## DESIGN PLAT

LYING IN SECTION 36, TOWNSHIP 9 SOUTH, RANGE 19 EAST CITY OF GAINESVILLE, ALACHUA COUNTY, FLORIDA

## 9. Petition 99SUB-05 DB

Causseaux & Ellington, PE, agent for Amy Fincher Ritch. Design plat review for 9 lots on 3.29 acres MOL. Zoned: RSF-1 (single-family residential, 3.5 du/acre). Located at 2502 Northwest 16<sup>th</sup> Avenue.

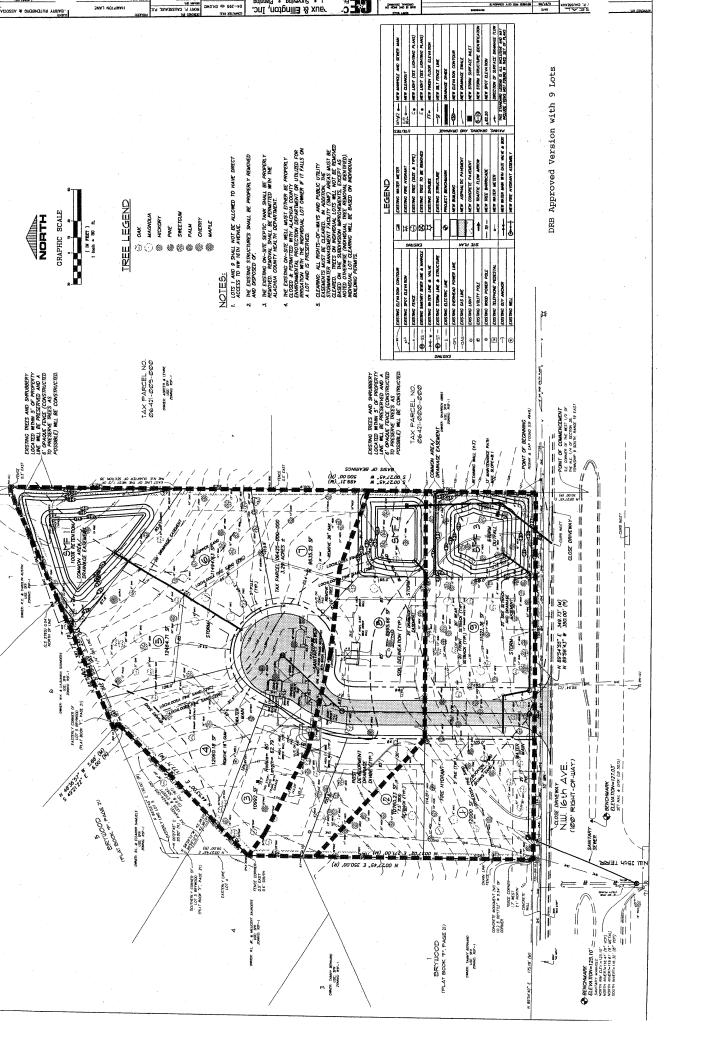
Chair Cooper noted that the staff report stated that none of the existing trees would be removed from any of the lots. She asked if trees would be removed for the retention basin.

Chair Cooper asked if there would be a tree buffer along NW 16<sup>th</sup> Avenue.

Mr. Shatkin asked why the board did not have a landscape plan with the petition.

Chair Cooper asked about the statement that no trees would be removed. She pointed out that it appeared that many trees would be removed.

Chair Cooper pointed out that, if the board approved the petition with 9 lots it would be agreeing that trees would be removed.

Chair Cooper stated that she did not believe the subdivision proposal met the requirements of the Comprehensive Plan. She indicated that she believed proposed density would affect the surrounding neighborhoods in a negative manner. She explained that she was not comfortable recommending approval to the City Commission when most of the trees would be removed.

Mr. Rutenberg stated that trees would be removed for the retention basins since they had to be graded to specific levels. He noted that there were requirements for landscaping after the basins were constructed.

Mr. Roberts stated that the trees in the stormwater management areas would be removed, however, the trees around the edges that were at the same elevation would be saved. He noted that the trees in the right-of-way would also be removed. He indicated that the Arborist also recommended that certain trees were removed because of their condition.

Mr. Roberts pointed out the trees along NW 16<sup>th</sup> Avenue that would be removed as required by GRU.

Mr. Roberts explained that the subdivision was in its preliminary stages and a landscape plan had not been finalized.

Mr. Francis indicated that the statement that no trees would be removed came from the site plan presented by the petitioner, however, trees would be removed in rights-of-way, retention areas and easements. He agreed that placement of a house would require tree removal, but except for the stated improvements, no trees would be removed until a house was constructed.

Mr. Francis explained that some developers would completely clear a site and it was staff's understanding that such clearing would not be the case with the proposed subdivision. He noted that a landscape plan would be required.

Motion By: Mr. Shatkin	Seconded By: Mr. Ingram
Moved To: Approve Petition 99SUB-05 DB with staff conditions and the recommendation to the City Commission that a minimum of 8 existing or planted shade trees be required per lot.	<u>Upon Vote</u> : Motion Carried 5 – 1 Yeas: Frankenberger, Shatkin, Collopy, Ingram, Higman, Nay: Cooper
